**NOTICE OF ADDENDUM**

**ADDENDUM NO. 1**

**CONTRACT NO. 6828**

**OLBRICH BOTANICAL GARDENS ROOF REPLACEMENT**

Attachment I- Olbrich Existing Skylight Shop Drawing  
Page 1

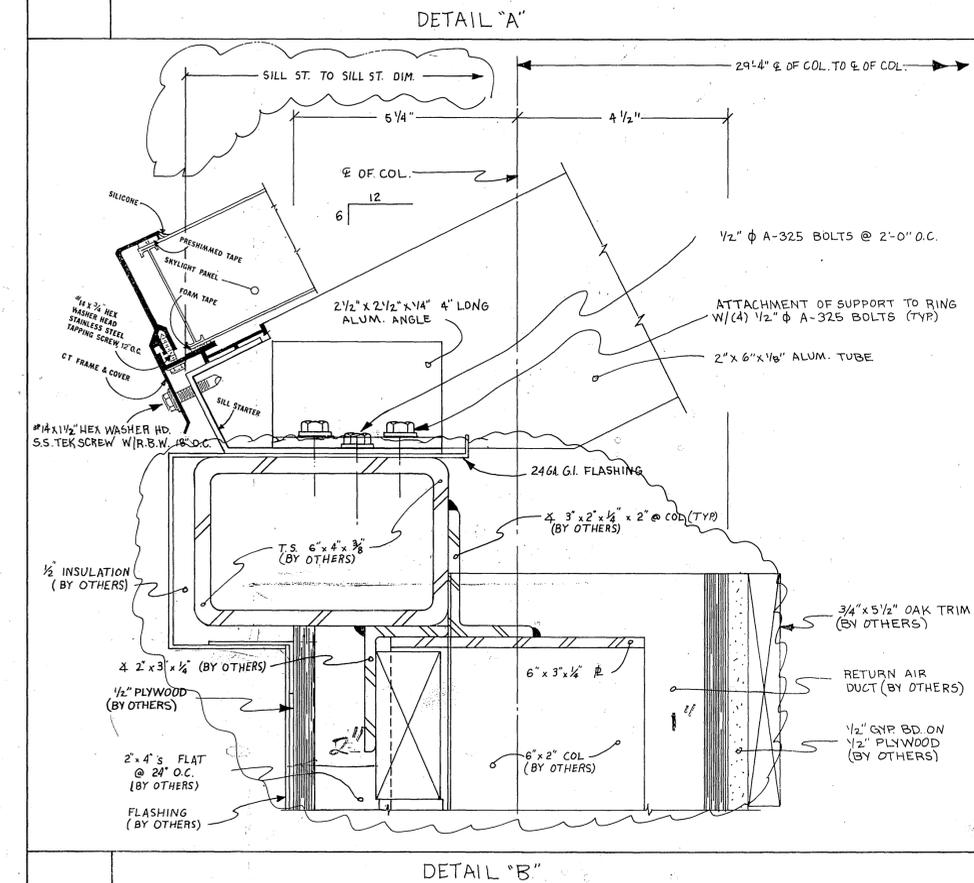
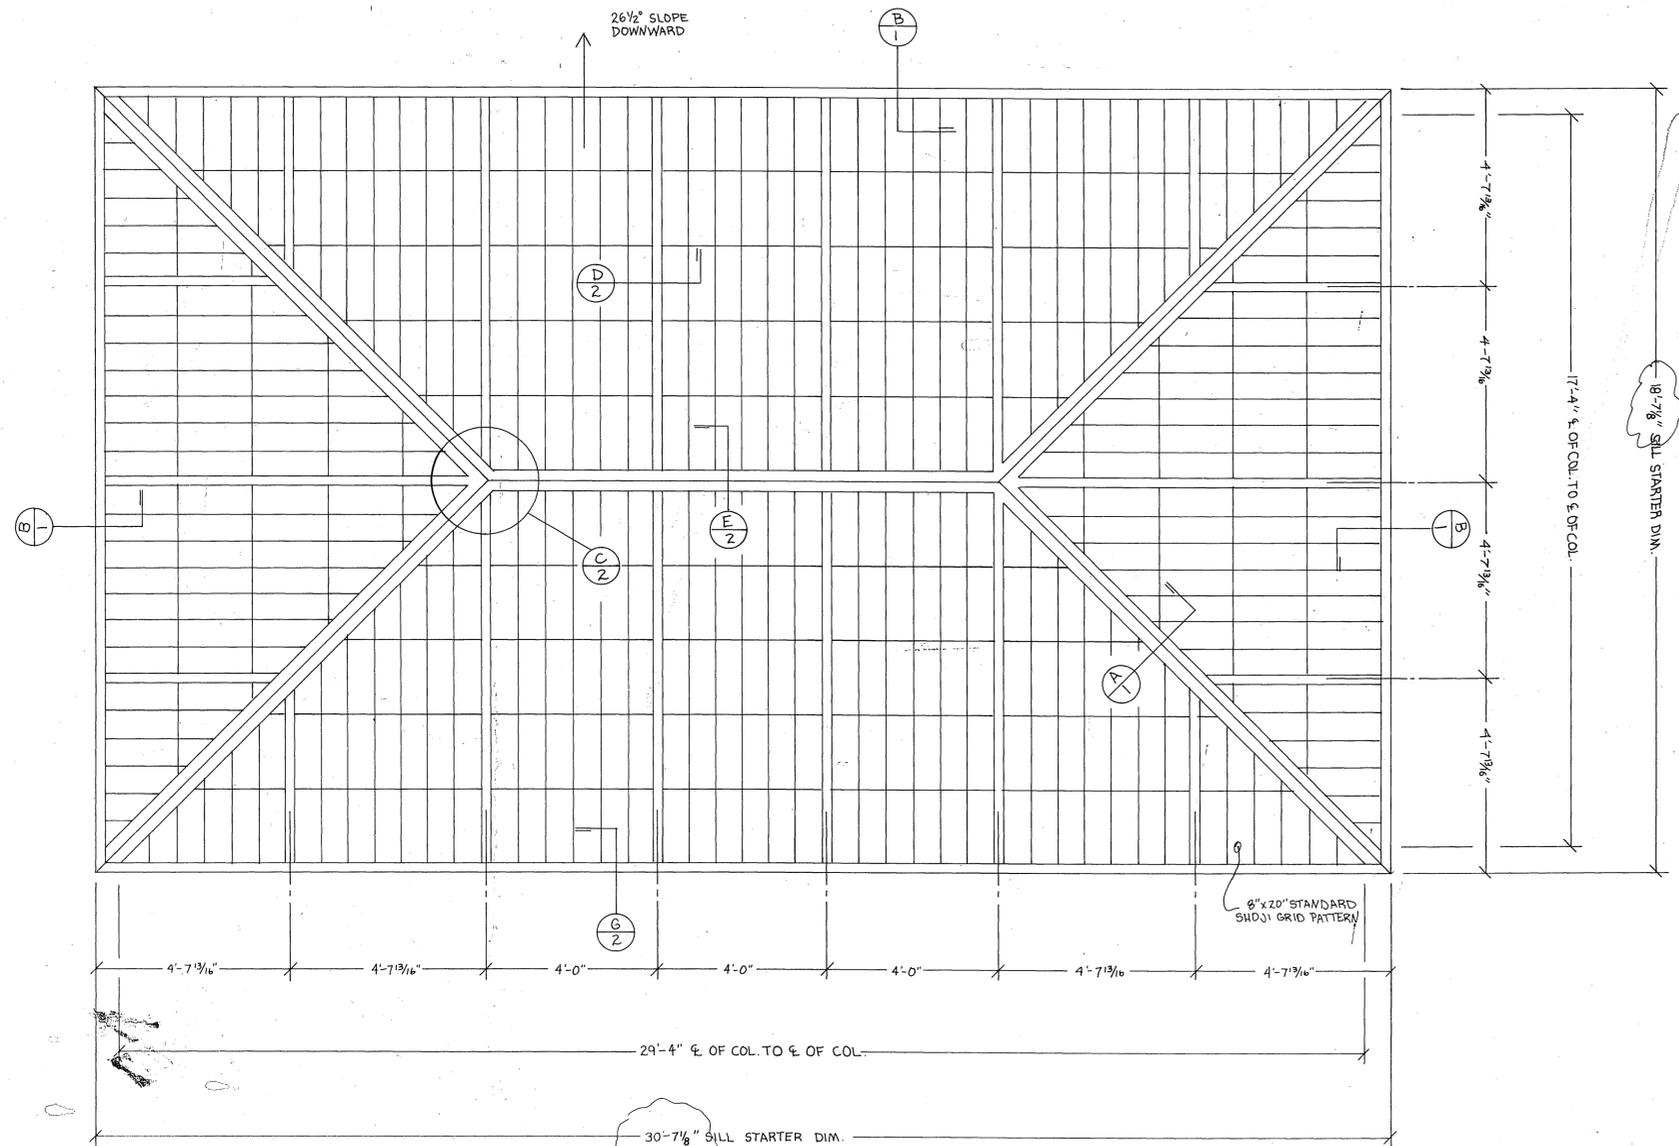
1. Section 01 0002, Part 1 – General, line 2 Pre-Bid Information: Shop Drawings for the existing lobby skylight are attached (Attachment 1, Olbrich Existing Skylight Shop Drawing). Note: The contractor is responsible to verification of all project on-site dimension verification.
2. Section 07 2100 – THERMAL INSULATION
  - a. Page 3, Article 2.6: Revise Paragraph A line 1: Change fire retardant plywood to 1/2”.
  - b. Page 4, Add 2.6, Paragraph E: Contractor may install the ventilated insulation in two layers. Overlap joints between layers. All insulation shall be matching product and be listed in U.L. Roof Construction No. 120 and 123.

SUBMIT STRUCTURAL CALCULATIONS FOR ALL MEMBERS & CONNECTIONS.

## Olbrich Garden Roof Drains Storm Water Sewer Lines

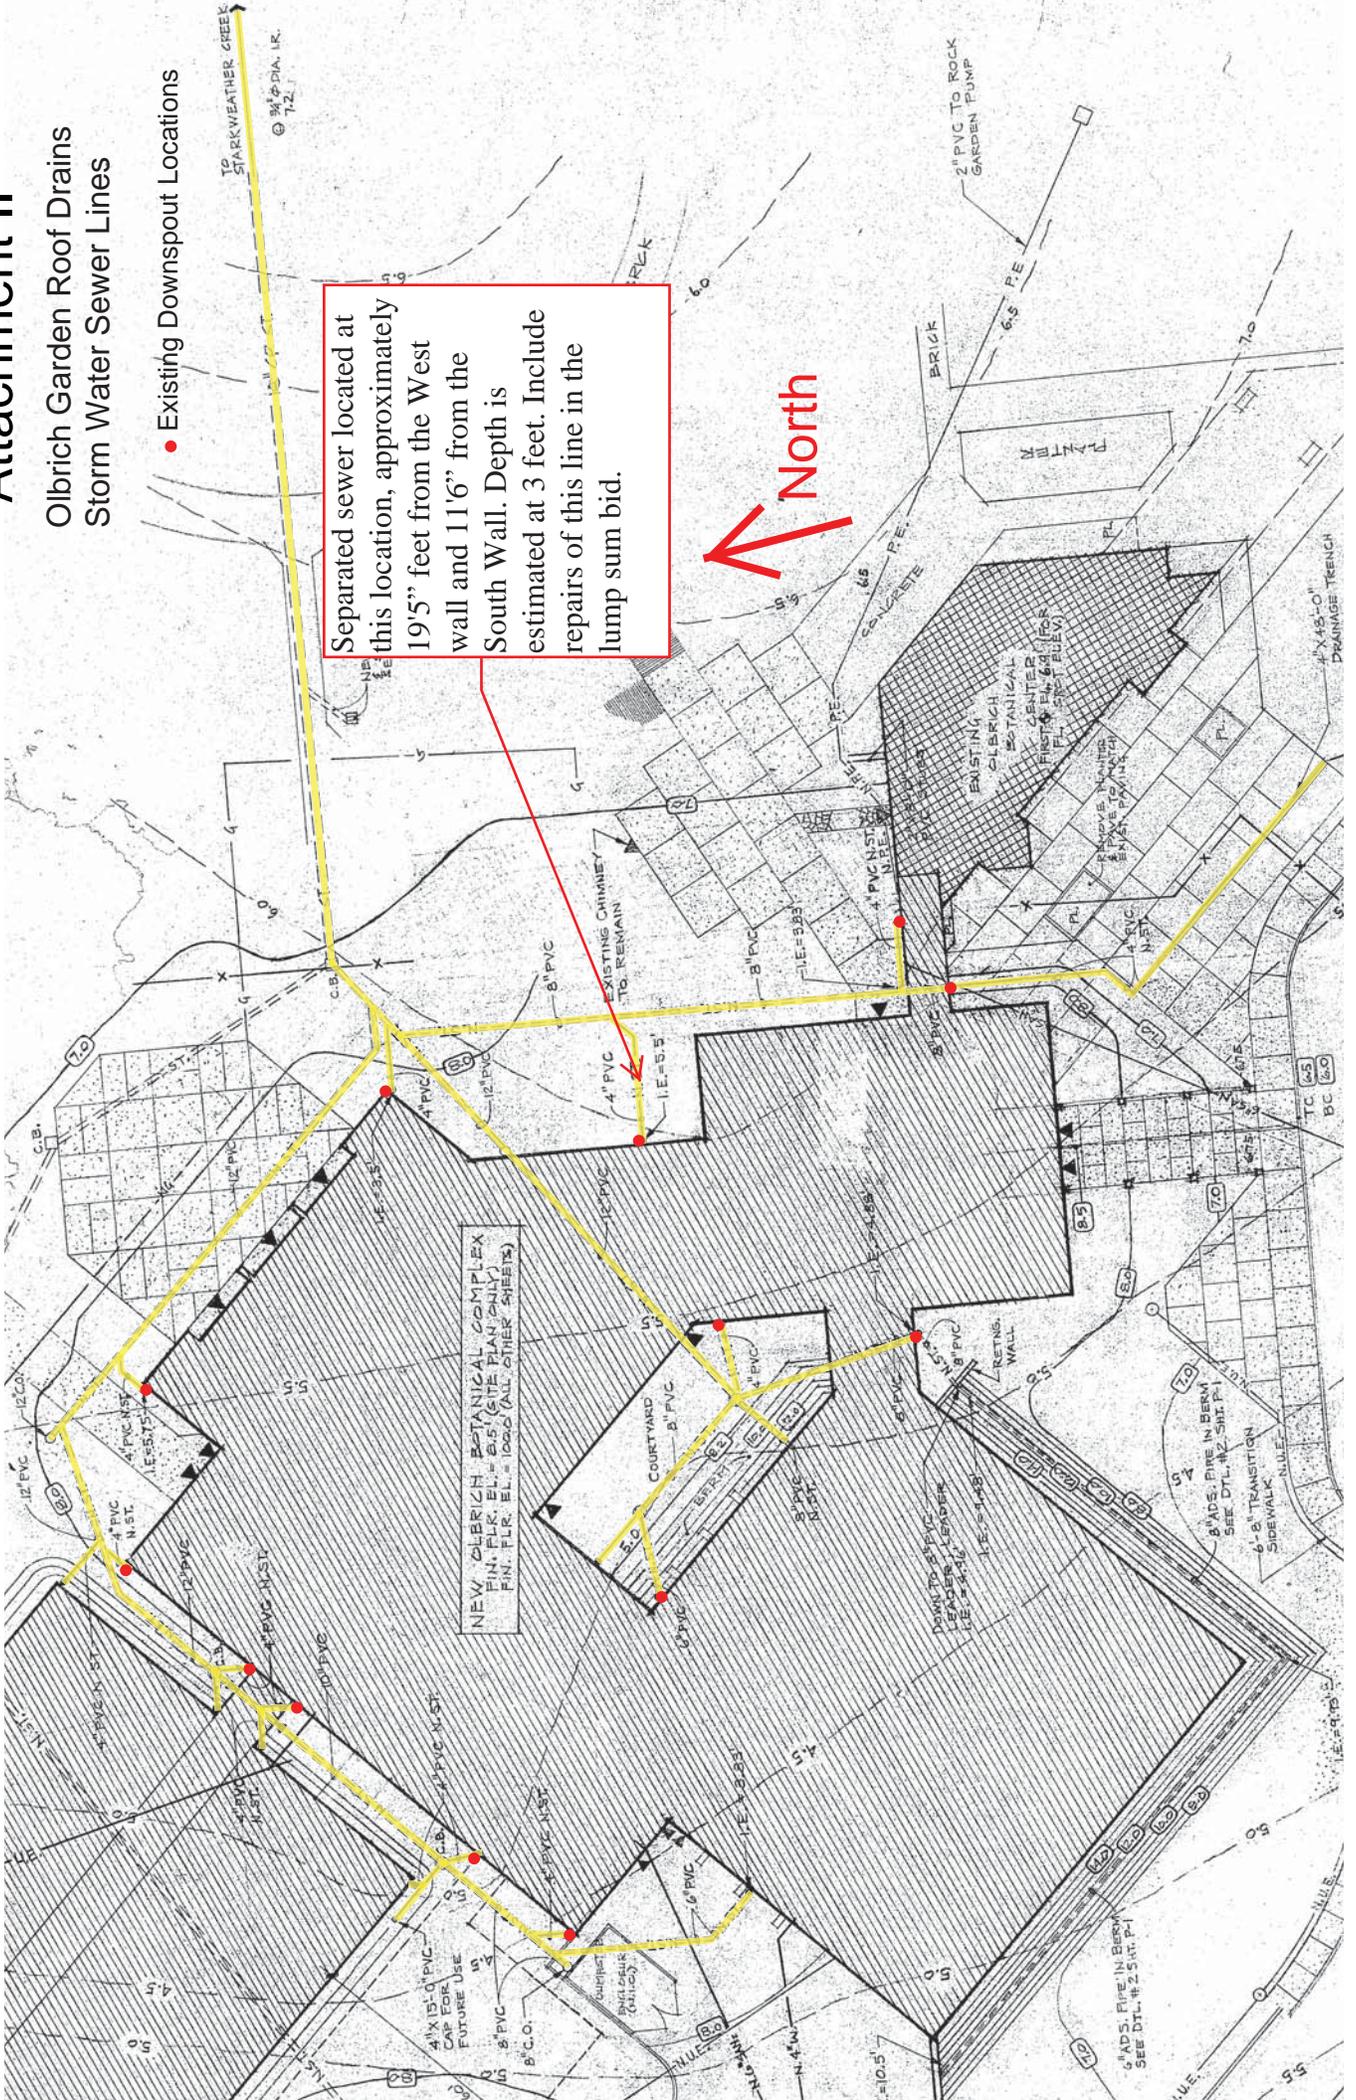
2. Sheet A1.1: First Floor Plan
  - a. Add note: Excavate approximately 3' deep and repair broken joint in storm sewer system southeast of the Lobby. Fill and compact excavation and restore site to specified condition. Refer to Attachment II, Olbrich Gardens Roof Drains Storm Sewer Lines for location.
3. Sheet A8.0 – Details
  - a. Add note to Details 3 and 4: Typical standing seams shall be double-lock type.

Separated sewer located at this location, approximately 19'5" feet from the West wall and 11'6" from the South Wall. Depth is estimated at 3 feet. Include repairs of this line in the lump sum bid.
